**PLANNED UNIT DEVELOPMENT
& PLANNING APPROVAL REPORT****Date: June 4, 2009****DEVELOPMENT NAME**

First Baptist Church of Carver Homes

Planned Unit Development Approval to allow offsite parking, and Planning Approval to allow a church in an R-1, Single-Family Residential District.

SITE PLAN

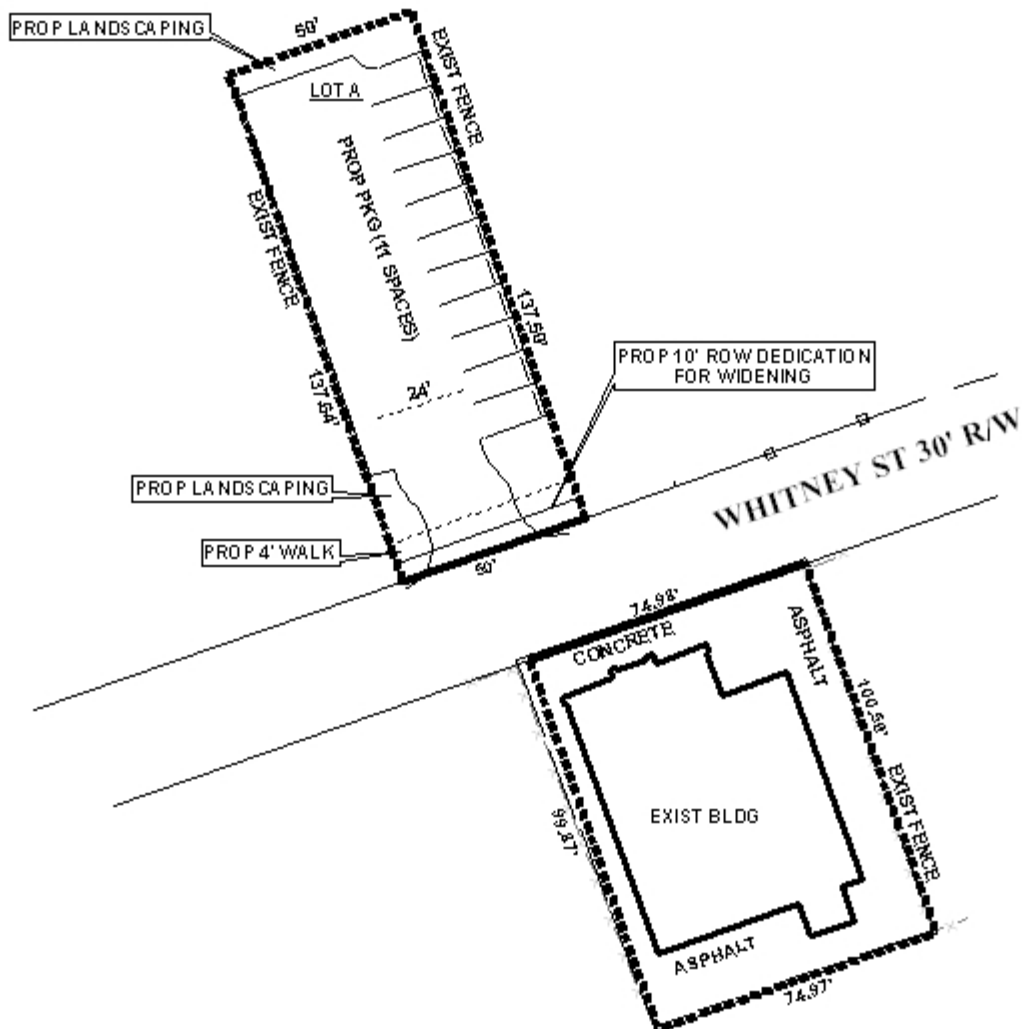
Driveway number, size, location, and design to be approved by Traffic Engineering and conform to AASHTO standards. There is not adequate maneuvering space for the parallel parking spaces as shown. If vehicles parked facing north there is not adequate space to maneuver into or out of the northern most space and there is not adequate aisle width to turn around to exit the parking area. If the vehicles parked facing south, there is not adequate aisle space to turn around to park in the spaces. Changes should be made to eliminate the spaces.

Currently, no parking exists for the church. With that said, the provision of parking would be beneficial, as it would reduce the impact on the surrounding neighborhood by alleviating congestion on the street. However, as noted by Traffic Engineering, there does not appear to be adequate maneuvering area for the parallel parking spaces. If cars parked facing North, then there will not be enough room to maneuver into or out of the Northernmost space. Even if cars were to park facing South, there does not appear to be adequate aisle width for turning around. The applicant should revise the site plan to eliminate the parallel parking spaces. Furthermore, the applicant should also revise the site plan to provide wheel stops.

With regard to trees/landscaping, the lot is currently vacant; thus, new development should require full compliance with Section 64-4.E of the Zoning Ordinance. While the applicant has illustrated some landscaping on the site plan, no calculations have been provided. If substandard, then some parking will need to be removed, or a variance application will be required. The same applies to trees, as it appears that full compliance will certainly require the removal of some parking.

There is no indication on the site plan as to the proposed location of any dumpster or other waste storage facility. The location of the storage area for the dumpster must be illustrated on the site plan and labeled, and the location and required screening must comply with Section 64-4.D.9 of the Zoning Ordinance, as well as with all other applicable regulations. If no dumpster is to be provided, then a note must be placed on the site plan stating so.

As illustrated on the site plan, parking concerns of Traffic Engineering have been addressed, along with the provision of wheel stops. Calculations have also been provided verifying compliance with landscaping requirements; however, there is no mention of trees. As mentioned previously, the applicant should be aware that if compliance with tree requirements is not

possible with the current layout, then either some pavement will need to be removed and the current applications amended, or a variance will be required.
